Docket Number:	13-AFC-01
Project Title:	Alamitos Energy Center
TN #:	214853
Document Title:	intervenor Los Cerritos Wetlands Land Trust - Part 2 opening testimony
Description:	N/A
Filer:	ELIZABETH LAMBE
Organization:	Los Cerritos Wetlands Land Trust
Submitter Role:	Intervenor
Submission Date:	12/16/2016 3:31:39 PM
Docketed Date:	12/16/2016

**INTERVENOR LOS CERRITOS WETLANDS LAND TRUST
Part Two Opening Testimony**

**Sections 1 and 2: Testimony of Bill Powers on behalf of the Trust
Sections 3, 4 and 5: Testimony of Joe Geever on behalf of the Trust**

Figure 1. Start-up timelines of Flex-Plant™ and conventional combined cycle plants¹¹

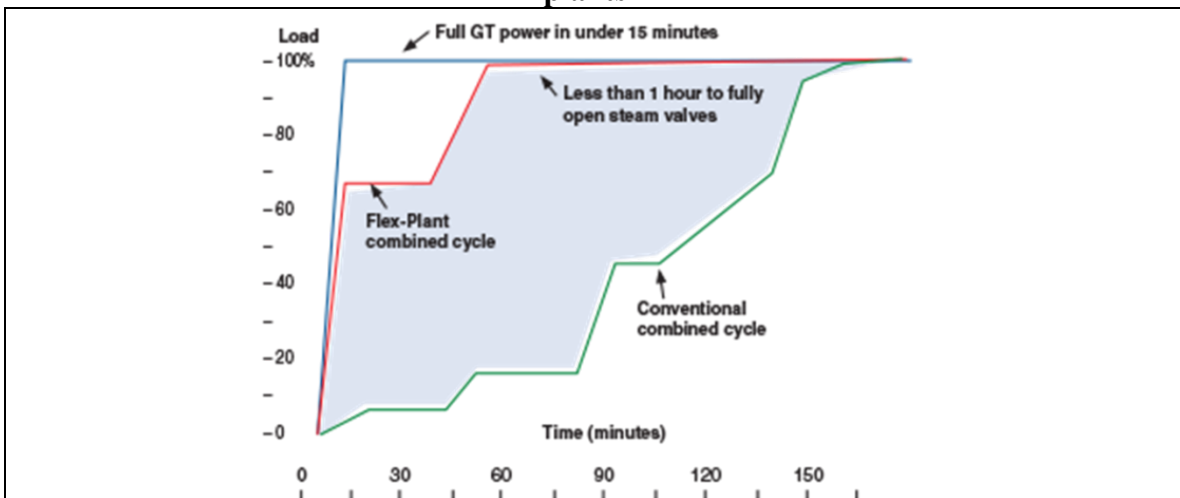
However, the 640 MW combined cycle component of the AEC does not meet the “less than 30 minutes” timeline to full power that defines the term fast start as used by the CPUC and the CAISO. The fastest start combined cycle configuration available on the market at this time is the Siemens combined cycle “Flex-Plant™” technology in use at the 550 MW El Segundo Energy Center that is owned by NRG and became operational in 2013.⁹ This combined cycle technology can provide about 55 percent of its rated capacity in 10 minutes, and requires approximately one hour to reach its full 550 MW rating.¹⁰

The Siemens Flex-Plant™ combined cycle technology is specifically designed to start as fast as possible, much more quickly than conventional combined cycle configurations, as shown in Figure 1. The GE Frame 7A.05 combined cycle technology proposed by AES for use in the AEC combined cycle block is slower start technology than the Siemens Flex-Plant™ combined cycle technology at El Segundo. The GE Frame 7A.05 is conventional combined cycle technology. As shown in Figure 1, conventional combined cycle technology provides little power at 10 minutes or 30 minutes into start-up, and takes 2-3 hours to reach full power.

A conventional combined cycle unit produces less than 10 percent of its rated output at 30 minutes, less than 20 percent at 60 minutes, and requires over two hours to reach full power. The GE Frame 7A.05 combined cycle configuration cannot be considered a fast start technology under the definition used by the CPUC and CAISO. The GE Frame 7A.05 does not meet a primary project defined in the FSA for the AEC. It is not fast start technology. In contrast, the GE LMS100 is designed to reach full power in 10 minutes and meets the CPUC and CAISO definition of a fast start resource.
